# Seismic Capacity and Strengthening Review

TRAMWAY HOTEL

114 ADELAIDE ROAD, WELLINGTON

Attachment 1- Sketches indicating concept seismic strengthening work

1.50 SECTION A  
0 1 2m

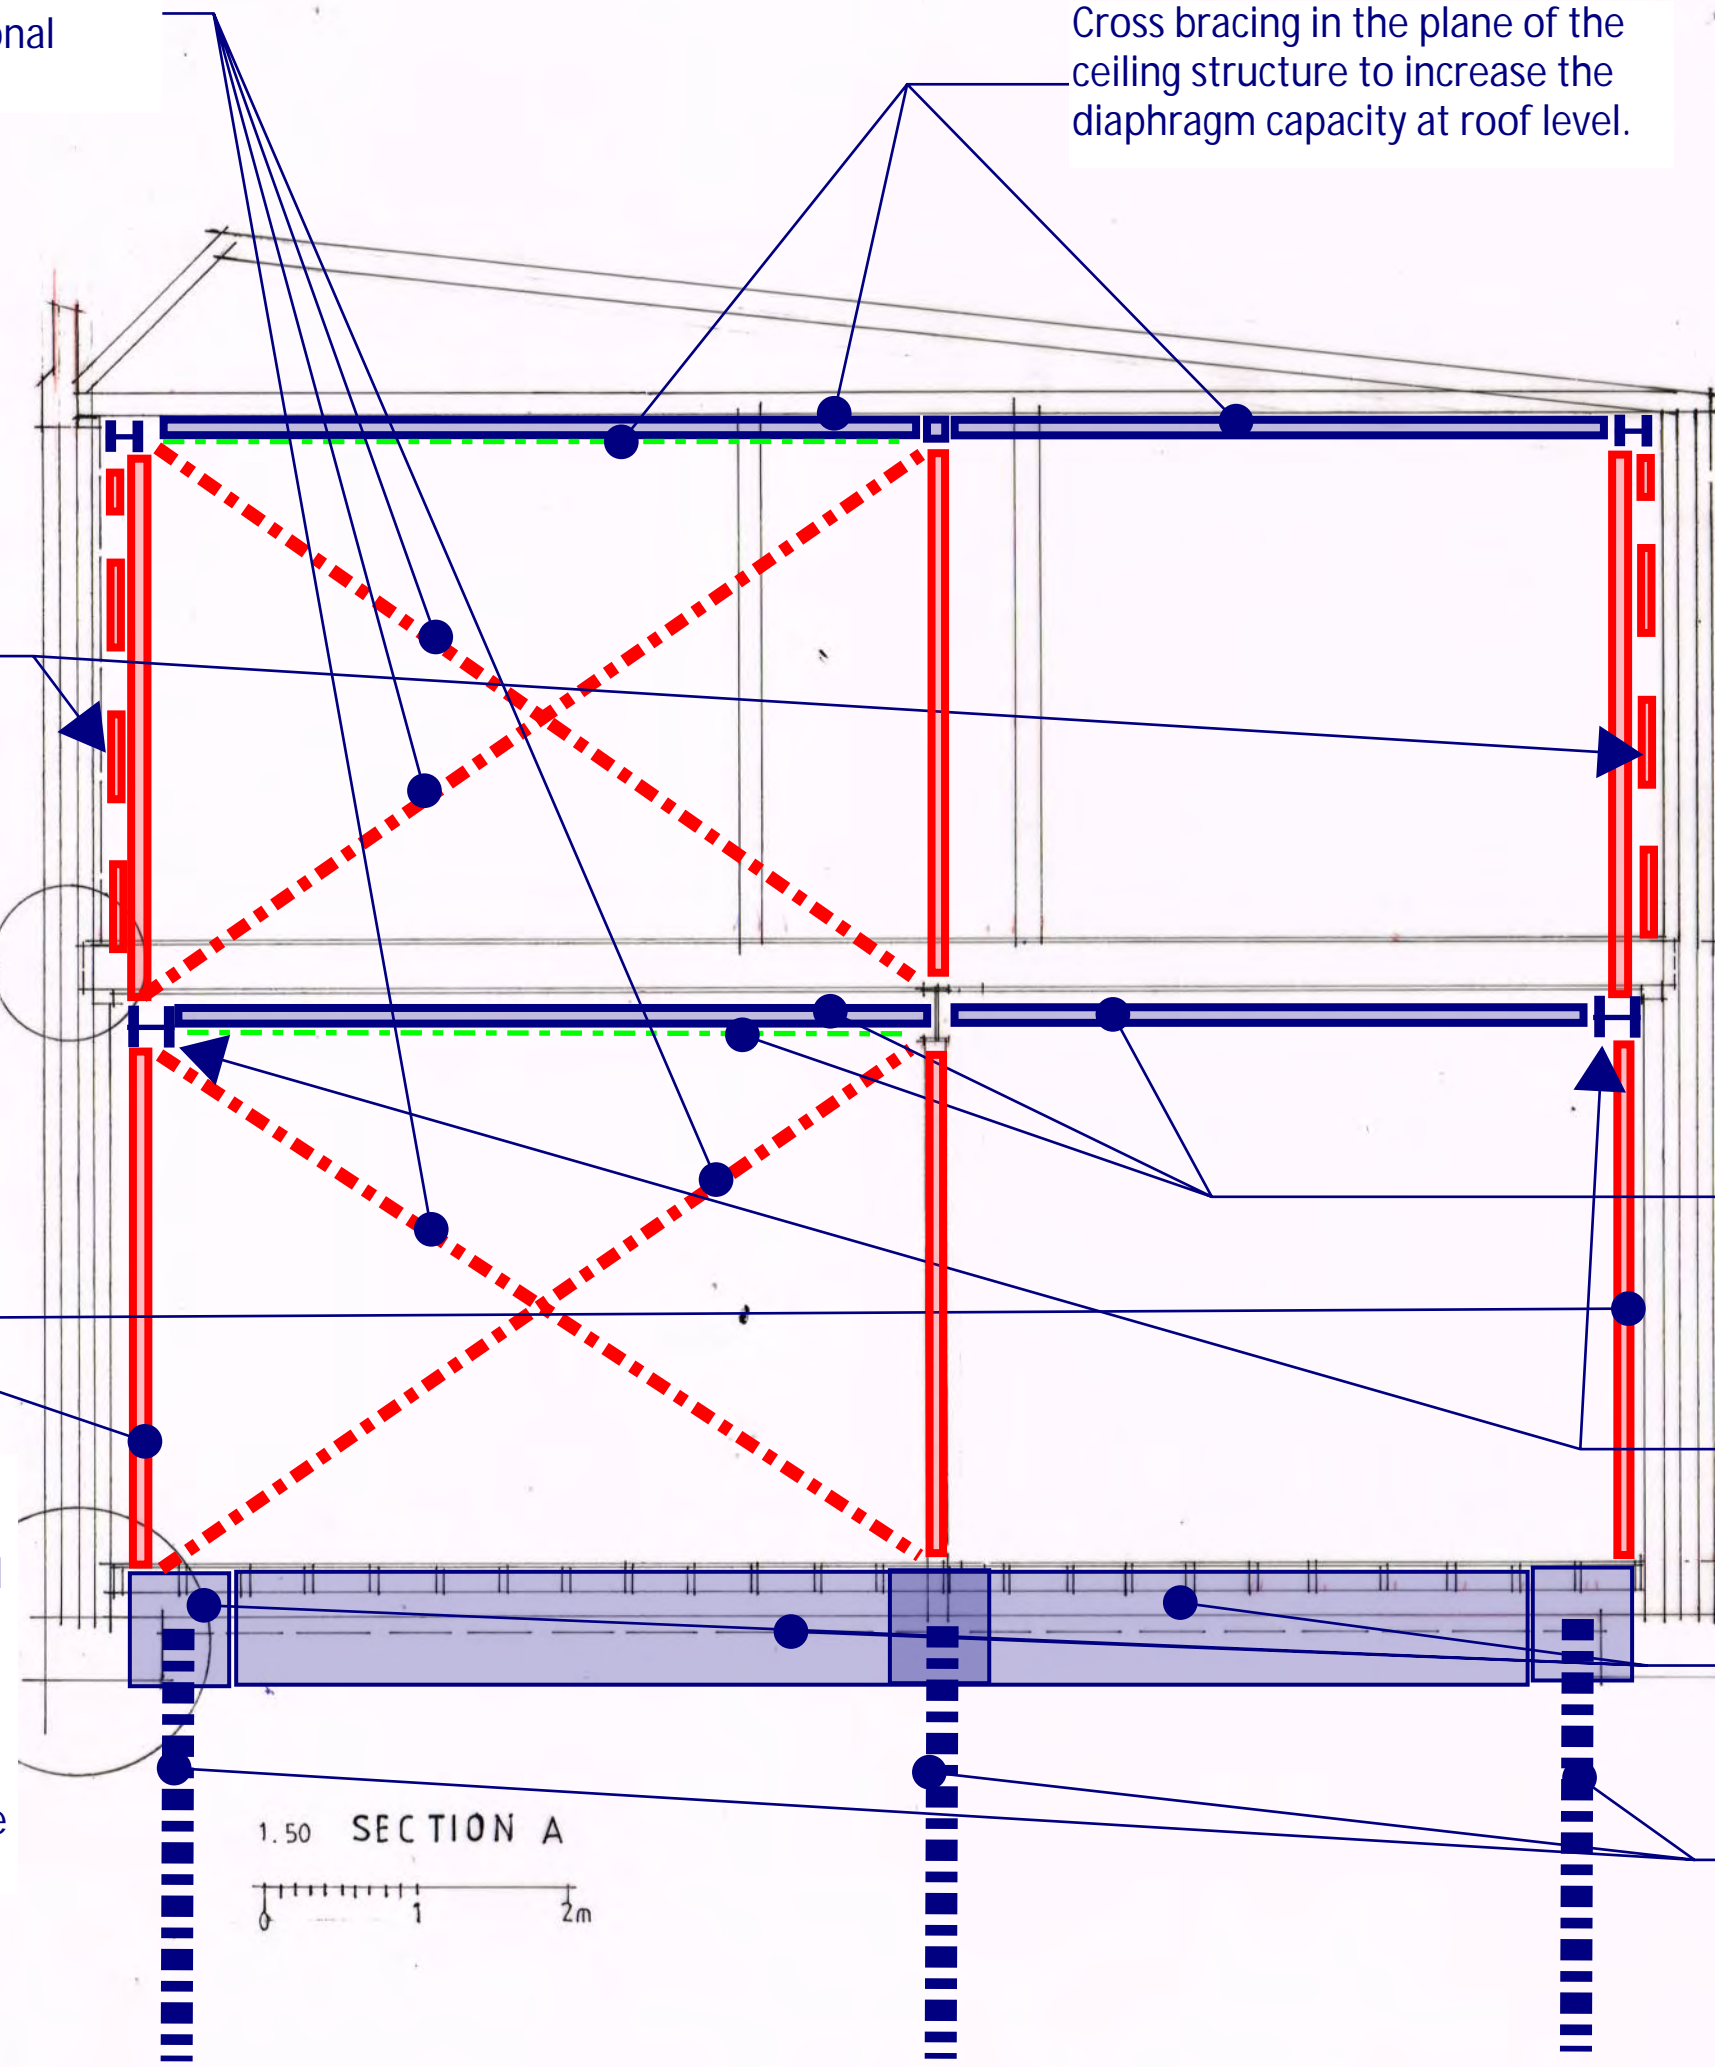
Internal cross bracing or concrete shear walls on two internal wall lines, one in each orthogonal direction.

Cross bracing in the plane of the ceiling structure to increase the diaphragm capacity at roof level.

If posts used will required packers at first floor level to allow for the reduction in wall thickness at first floor level.

In or under the plane of the first floor steel cross bracing members to increase the diaphragm capacity at first floor level. Diaphragm transfers seismic demands to vertical bracing elements

Wale beams to provide out-of-plane restraint to URM walls and transfer demands into the strengthened floor diaphragm.

Ground beams anchored to the URM walls that support the bracing elements above.

Piles that found in weathered rock material at least 3m below ground level.

Post or sprayed concrete on outside URM walls lines. If posts these would resist out-of-plane demands on the URM walls and some post also have steel cross braces to adjacent posts to increase in plane capacity.
